**PLANNING & ZONING COMMISSION
REGULAR MEETING
Wednesday, December 6, 2023 – 7:00 PM
Town Hall Meeting Room 1**

RE: Site Plan and Special Permit Application – 131 Linwood Avenue

Project Title:
PROPOSED COMMERCIAL DEVELOPMENT
 131 LINWOOD AVE
 COLCHESTER, CT
 Issued For:
Definitive Site Plan

DATE: November 30, 2023

Drawing No.
C-1

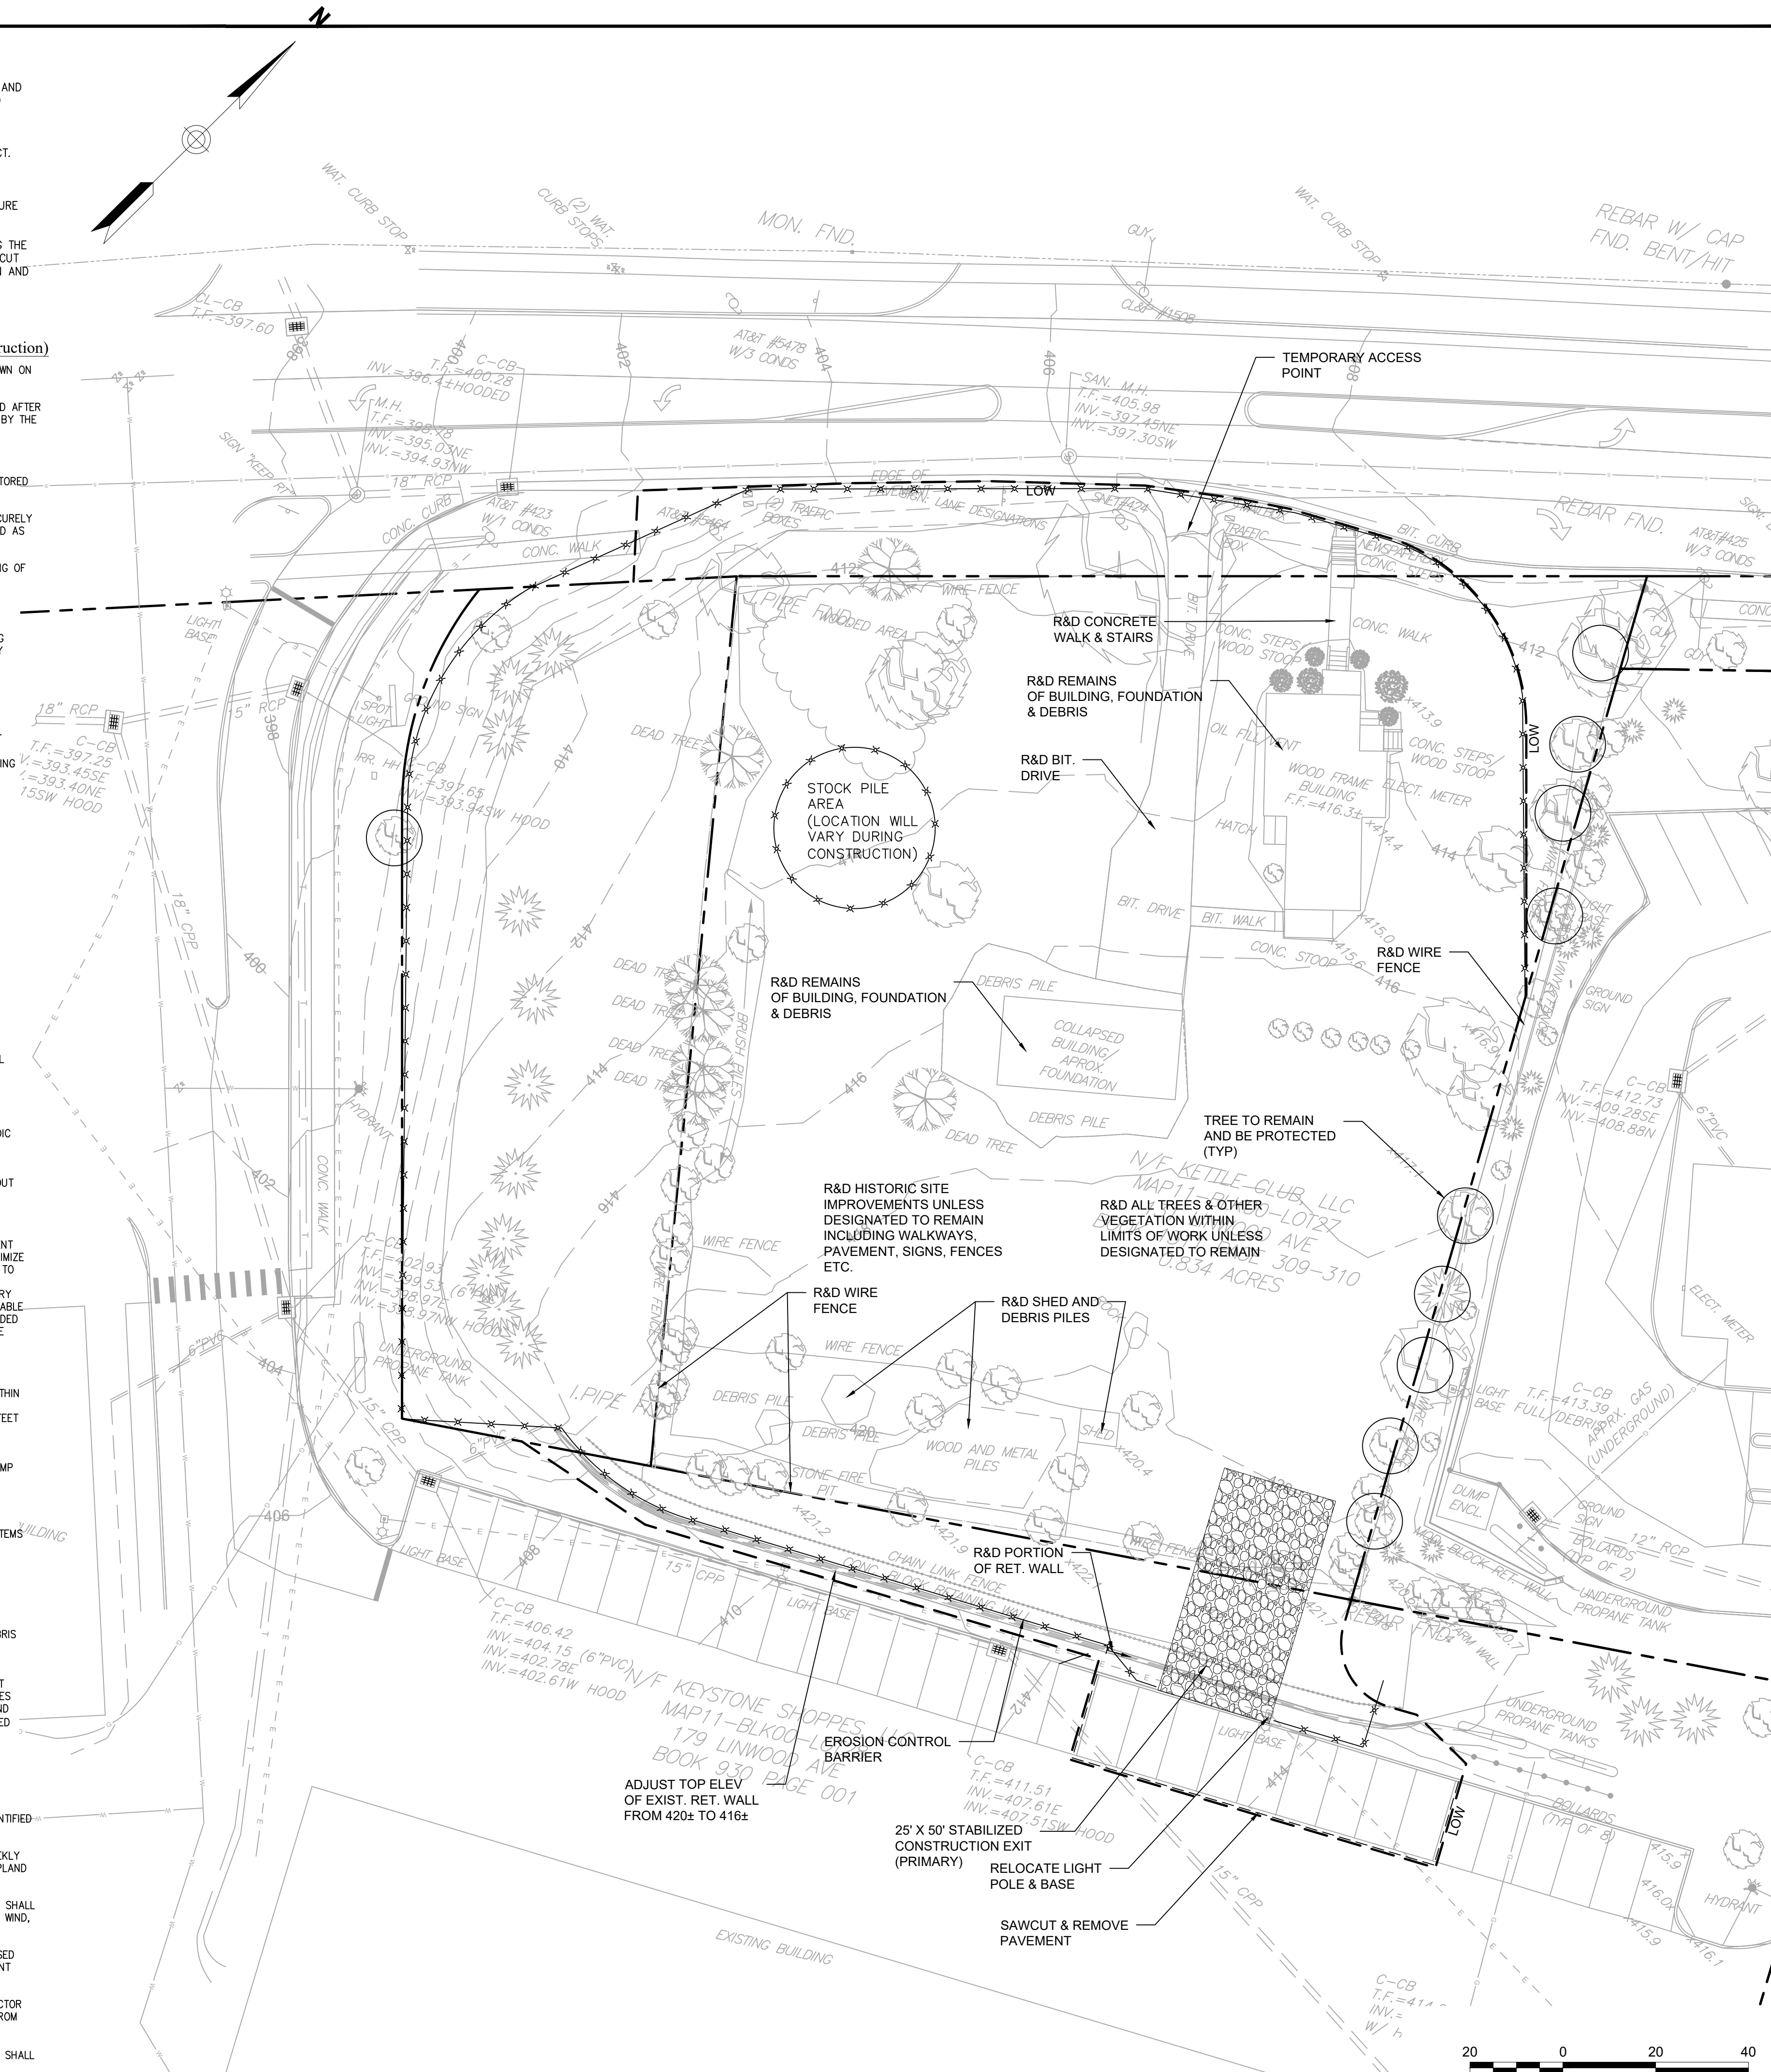
- 1) Plans need to be signed and stamped by all professional preparers including P.E. and L.S.
- 2) Sheet C-1 Demolition Note #5 refers to a March 11, 2011 GSI Engineering Report. Is this pertinent to this project or is this an erroneous reference?

- 3) Sheet C-1 Demolition Note #10 erroneously refers to sheet C-6 for E&S controls.
- 4) The Zoning Summary chart on sheet C-2 appears to show an erroneous number of required parking spaces (251). This chart also indicates Total Parking provided is 47 spaces, however; the site plan shows 54 total spaces.

Drawing No.:
C-2

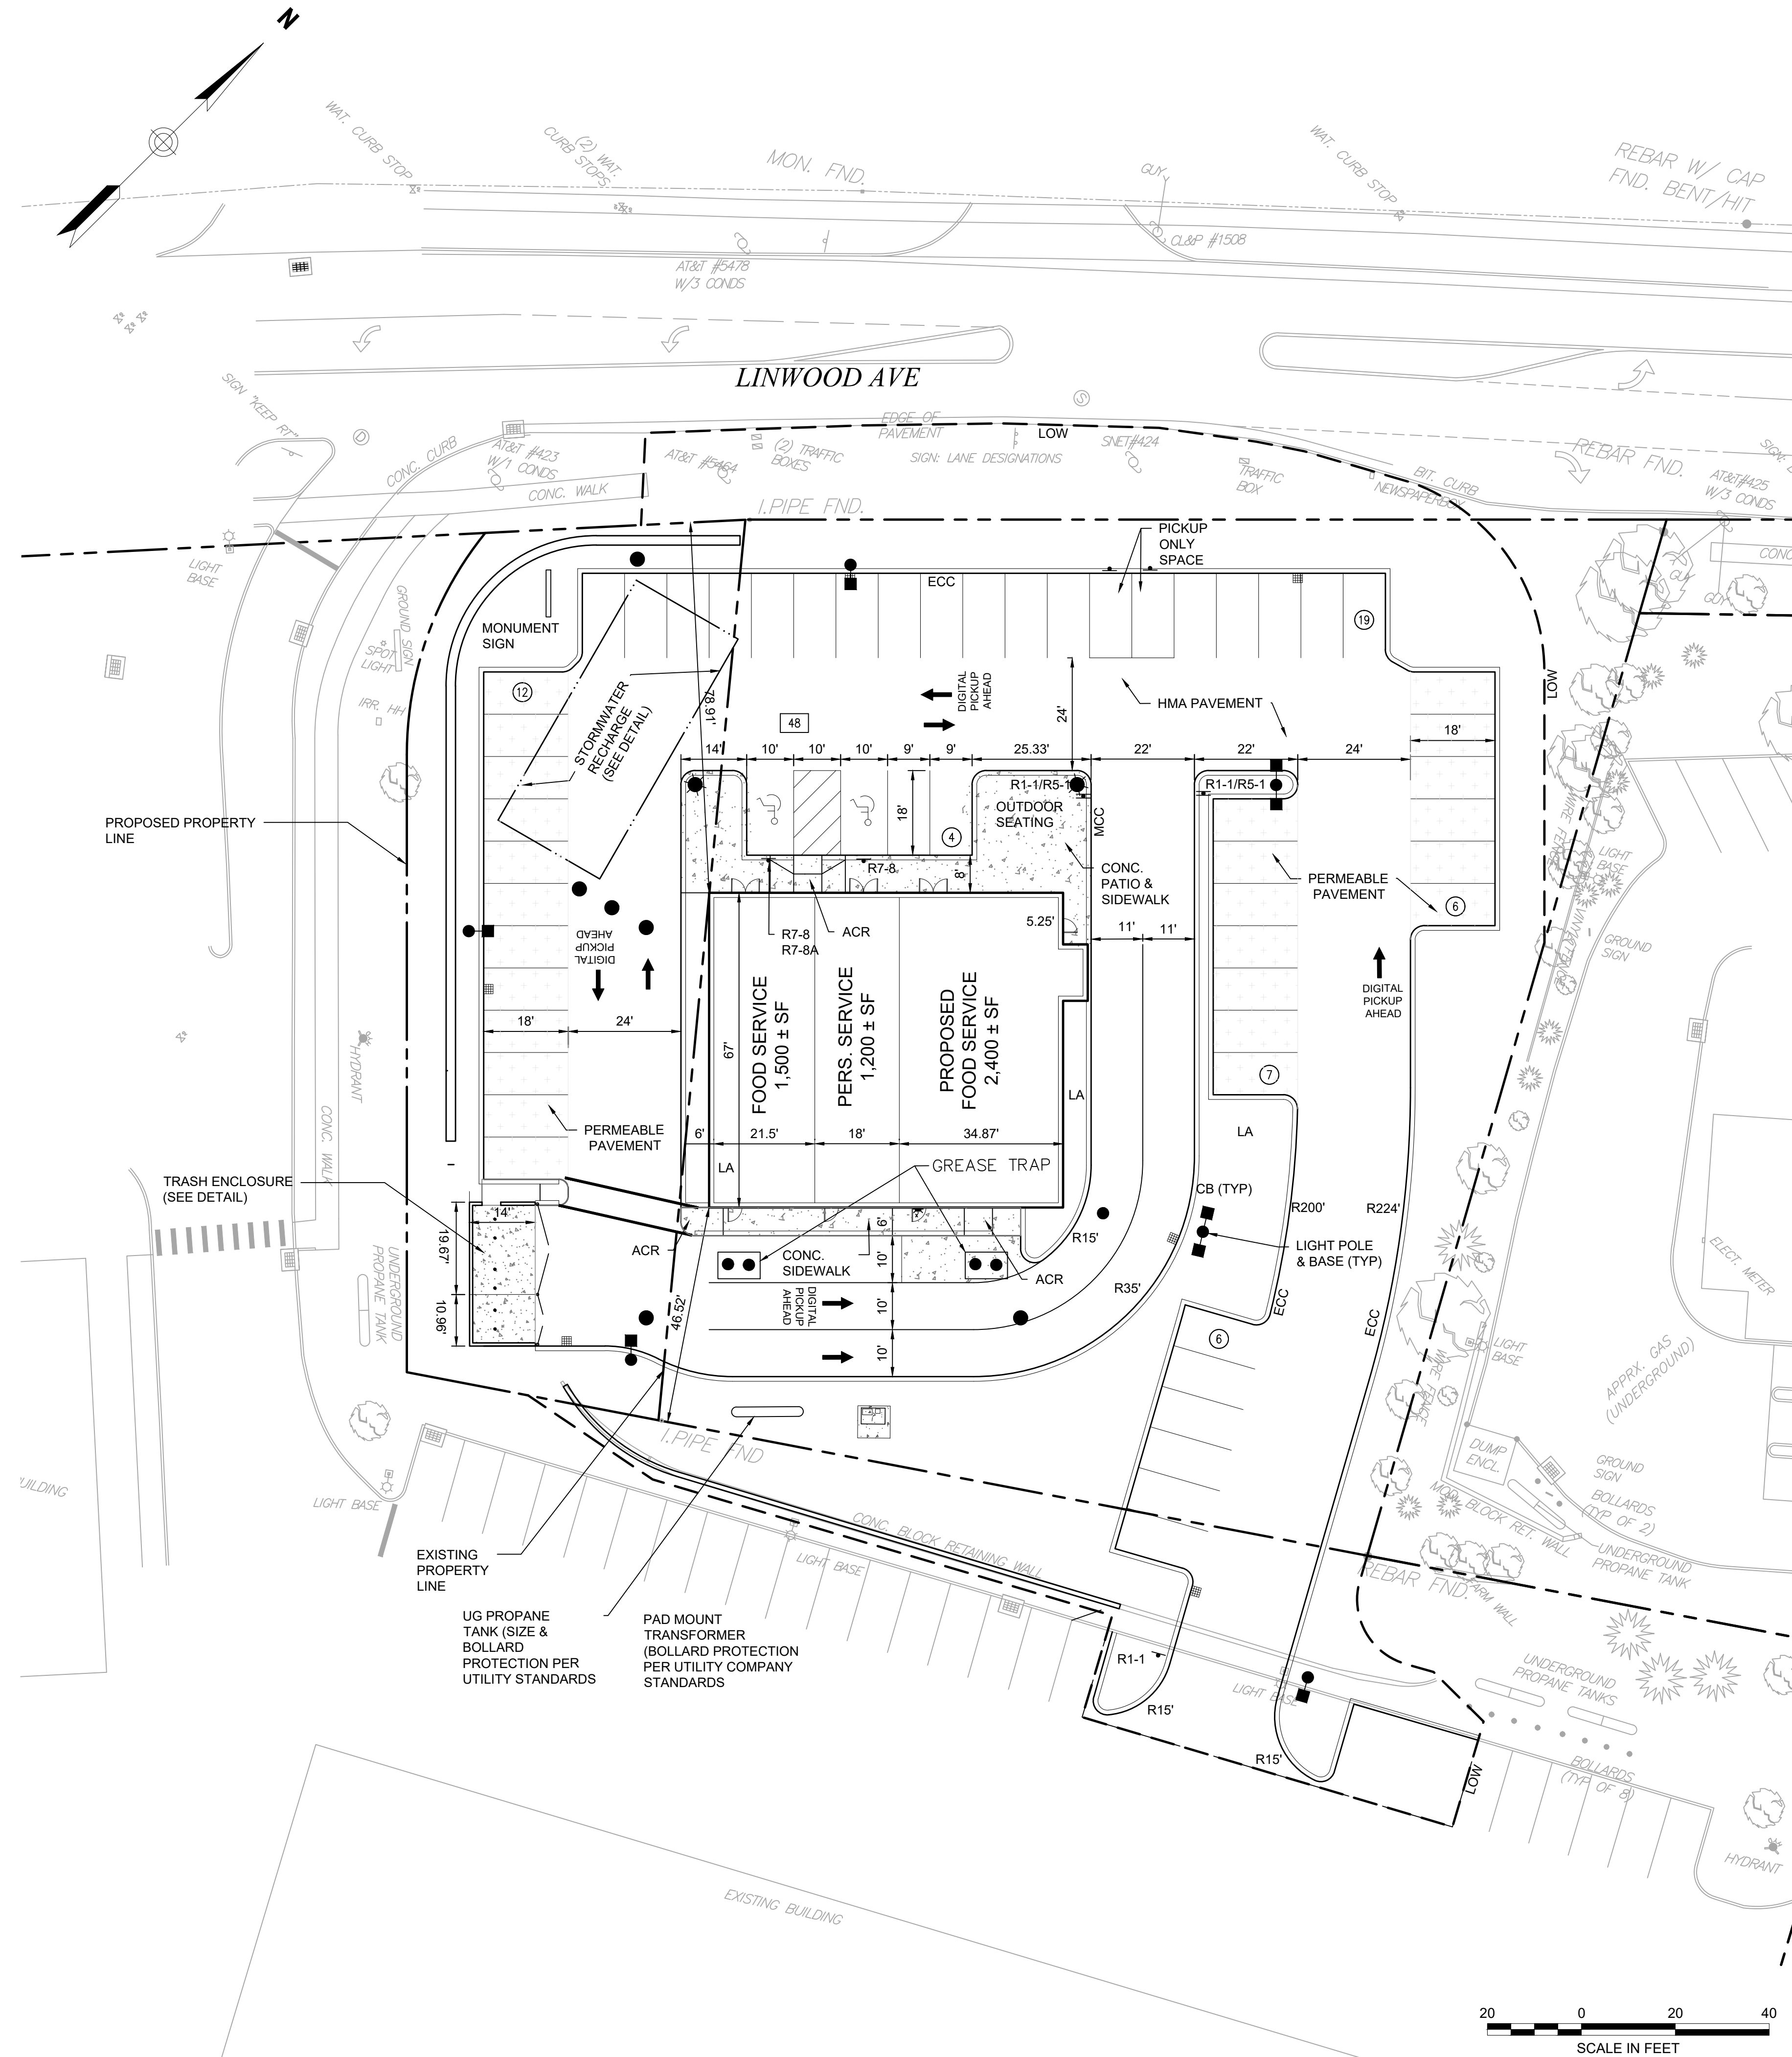
- 5) The Layout and Materials Note #2 on sheet C-2 refers to striped loading spaces. Where are these located?
- 6) The proposed property line shown on sheet C-2 will necessitate cross easements between the impacted land parcels. Need to depict all proposed easement limits and indicate purpose of easements on plans.
